HOWARD COUNTY HISTORIC PRESERVATION COMMISSION
ELLICOTT CITY HISTORIC DISTRICT ■ LAWYERS HILL HISTORIC DISTRICT
3430 Court House Drive ■ Ellicott City, Maryland 21043

July Minutes

Thursday, July 1, 2021; 7:00 p.m.

Figure 5 - Proposed reconfiguration of Lot 5 (8308 Main Street), with the addition of 1,985 square feet (shown in solid yellow with dashed lines) from 8312 Main Street/Parking Lot E.

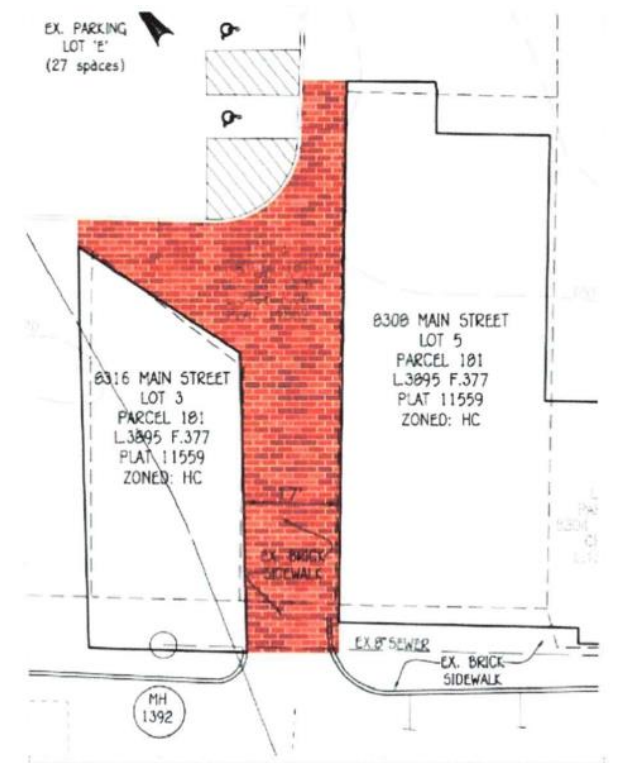
Mr. Roth asked Mr. Hemmis if it was correct that he did not currently own the land between the buildings and asked Mr. Hemmis how he was purchasing the land. Mr. Hemmis said that was correct that he did not own the land and explained the subdivision and County Council surplus process that had to take place for him to purchase the land. Mr. Hemmis said that he did not need to purchase the land and would be fine with an easement, but that was not a possibility with the County due to the sale of alcohol. Mr. Roth asked how the value of the land was determined. Mr. Hemmis said he is working with DPW Real Estate Services and he has to obtain appraisals and then it goes to County Council for a surplus vote. Mr. Hemmis said the outdoor seating in the courtyard has saved their business through the Covid crisis. He said it is a benefit to town. He said he is trying to create a pedestrian friendly environment. He said the 44-inch easement number was told to him by the County, it was not a number he came out with.

Ms. Zoren was concerned that a 44-inch easement was not going to be wide enough. She would like to see the easement wider so that people know it is still a public access point. Ms. Zoren asked if they intended to rope off the seating. Mr. Hemmis said the County does not want to see permanent fencing installed into the ground there. He said they need to find the right mix and find something that looks appropriate to fence off the seating. Mr. Hemmis said the 44-inch easement is wider than the sidewalks in Ellicott City. He explained the 44 inches is measured off of the benches that exist on that side of the

building, rather than the side of the building. They are trying to leave plenty of room for egress. Ms. Zoren said she would not be able to approve the barricade in the package. She suggested movable planters. Mr. Hemmis said that have rubberized kegs that say Ellicott Mills Brewery that could serve as fence bases. Ms. Zoren summarized her Advisory Comments and said that exposed aluminum frames were not appropriate and the materials should be in the realm of black metal, not silver. Ms. Zoren said 60 inches is the ADA minimum if someone needed to turn around in a wheelchair, especially in a thoroughfare used for emergencies. She explained that 60 inches would allow someone to turn around in the walkway, rather than having to get through it in order to turn around.

Mr. Roth said his advice was to remember that it is a public way. He said the application reads as the access being for ADA and emergencies and Mr. Roth said that if he is a wheelchair he should be able to get through and not feel stuck. Mr. Roth said he has concerns about 44 inches. Mr. Hemmis said it is wide open public way, not just for ADA and emergency.

Mr. Shad agreed with the other Commissioner's comments on widening the access if possible and asked Mr. Hemmis to bring more options for furniture back to them to review at a later date if it goes forward.

Figure 8 - Front of historic house to be demolished.

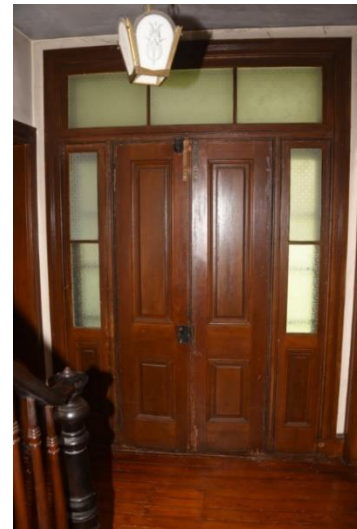
Mr. Roth said the house was a lovely old house and it was sad to see houses like this go. His Advisory Comments were to fix the house up and said feral cats and termite damage can be fixed. He said you cannot recreate the details, such as the arched windows, staircase and banister and encouraged them to preserve and keep the building.

Ms. Zoren strongly agreed with Mr. Roth. She said the Commission often gets houses coming before them for demolition in poor condition that are falling apart, with caved in roofs. Ms. Zoren said that does not appear to be the case here and the house appears in reasonably good condition. She said it appears to be structurally sound from the photographs, the interior has a lot of original and valuable detail with the doors, the stairs, the interior woodwork. She said the L houses are configured to easily add additions to in order to support a growing family. She said they have seen an uptick in homes like this, the Commission has approved thousands of dollars in tax credits for a similar house in Western Howard County and explained the house was in much worse condition than this one. Ms. Zoren has no concerns with the second homesite, but advised against the demolition.

Mr. Shad echoed the same concerns of the previous Commissioners. Mr. Shad stated that he lives in a similar home type from 1867 and explained that these homes are built to last. He strongly recommended the Applicant preserve the house.

Figure 9 - Intact historic features. From left to right: exterior view of front doors; interior staircase, newel post, balusters and wood floor; interior view of front door, side lights and transom.

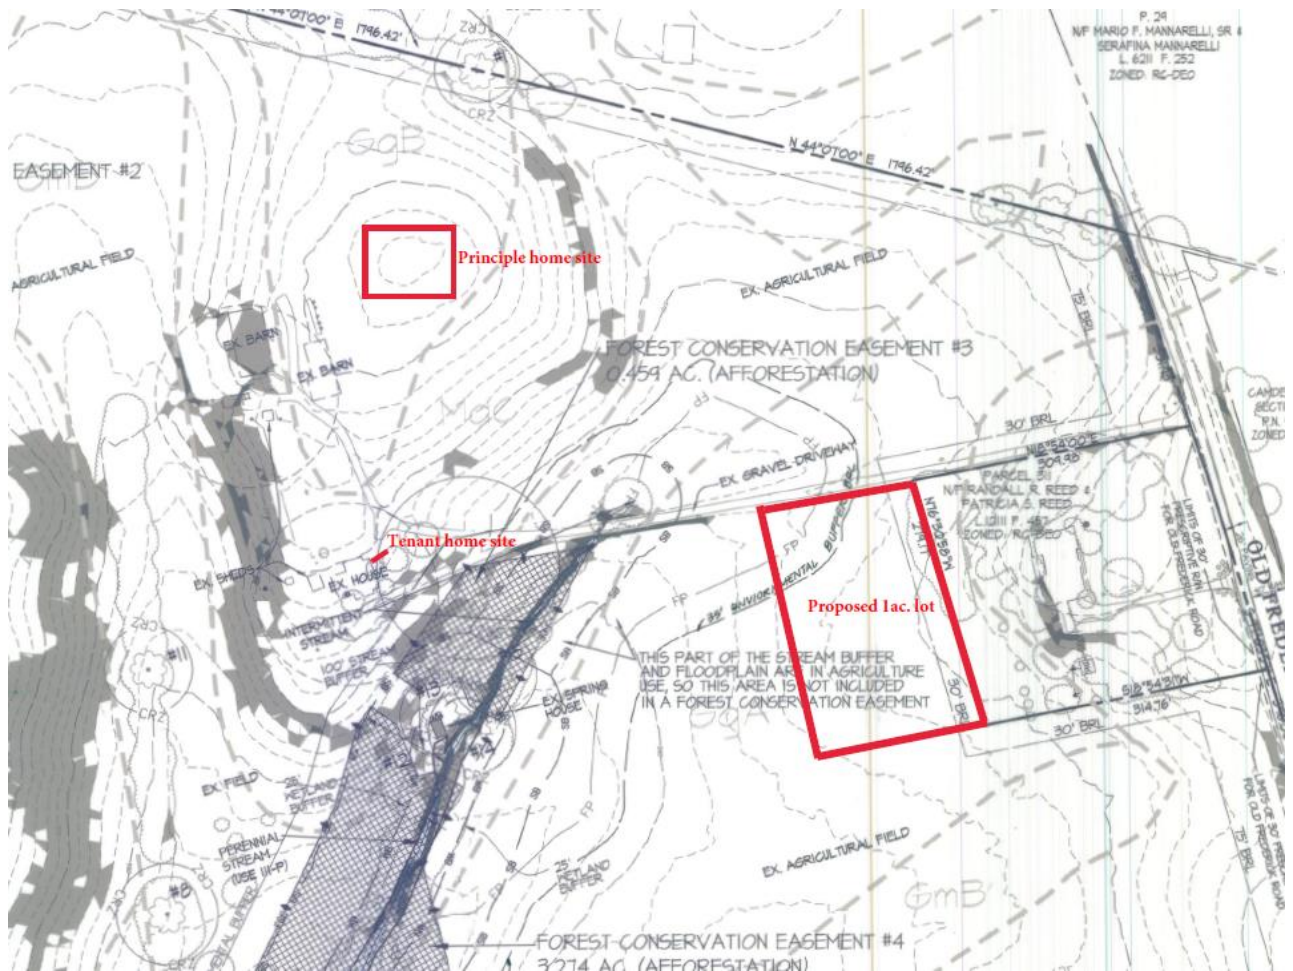
The Secretary of the Interior Standards encourage the rehabilitation of the property, while maintaining integral historic features. In this case, the historic structure is not proposed to be retained, but many of the interior features do not appear severely deteriorated, as evident by the photos in Figure 9.

Figure 17 - Rear view of enclosure and deck

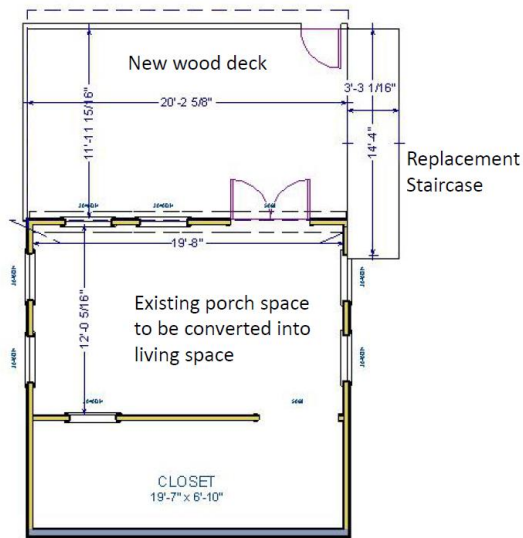
Ms. Zoren referenced Figure 12 and 17 regarding the new roof and enclosed wall. She said the new wall appears to go up above the current roofline in Figure 17 and asked if that was an error in the rendering. Ms. Zezzo said it must be an error because she told the contractor they are not going any higher. Ms. Zoren asked the Applicant if the intention was for the new wall to not interfere with the existing roof and gutter layout. Ms. Zezzo said that was correct. Ms. Zoren asked if they planned to finish the area under the porch, with the brick piers. Ms. Zezzo said the brick piers will stay and it will remain open on the east and north side. She said on the west side, there is a lot of wind and the contractor said he will build a wall using brick and mortar to match the piers on the west side and the brick piers would stay. Ms. Zoren said if it is different from what is there now, to notify Staff. Ms. Zoren asked if the HVAC unit will be shifted. Ms. Zezzo said it will just be shifted to the back. Ms. Zoren expressed concern on the unfinished cedar and said that having two completely different siding types and colors under the same roof form will look strange. Her recommendation would be to paint the siding a complimentary color to the existing cream German lap. Ms. Zezzo explained that the other side of the addition is all stone and that the side shown in the staff report is the only side that has wood frame siding. Ms. Zezzo said the rear addition was put on in 1899 and she wondered if they ran out of stone because it is only place wood is used. Ms. Zezzo would like to build it and see how it looks and if it looks odd, then paint the one side only. Ms. Zezzo does not want to paint the entire addition and thought it would look strange to have white against the stone. Ms. Zoren said the painted cedar addition would look the same as the painted siding currently looks against the stone. Ms. Zezzo was not sure which color she would use if she painted it. Ms. Zoren said the current siding could also be painted, if approved, so it is all one color. Ms. Zezzo was open to painting one side of the new addition adjacent to the existing wood siding, but wanted to find a historic/earthy color. Ms. Zoren wanted to see the entire addition painted, not just one side. The Applicant would want to paint the one side next to the wood, but thought white paint next to granite would look odd.

Figure 21 - Remove asphalt shingle from dormer and install GAF Weatherside Purity fiber cement shingle.

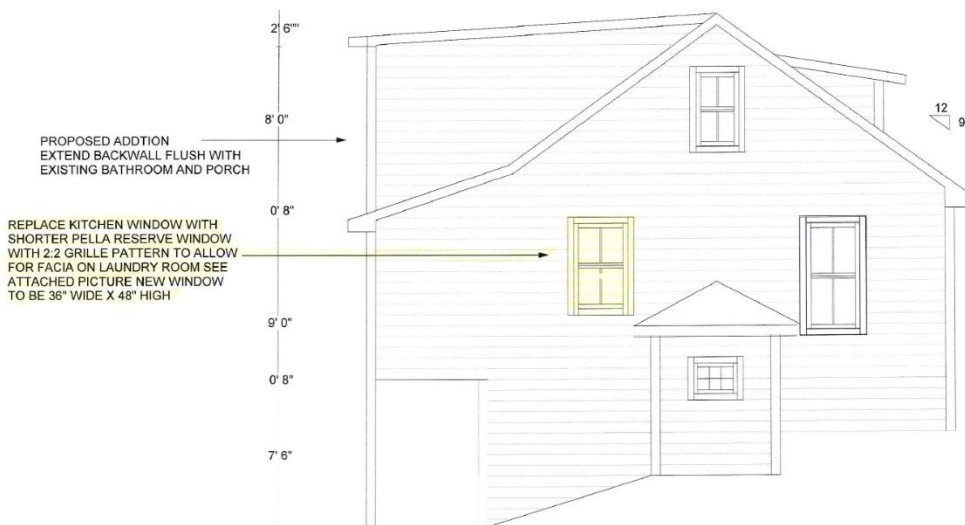
The application originally proposed to remove the asphalt shingle from the front dormer and add GAF Weatherside shingles (designed to mimic asbestos). But since the front of the building is sided in wood German lap siding, Staff inquired with the Applicant on the proposal for asbestos versus wood or a composite to match. The Applicant indicated he was not opposed to using German lap if preferred. Staff recommends the HPC discuss this item with the Applicant. Wood would be the most appropriate, to match the front of the house and would also qualify for the 20.112 tax credit.
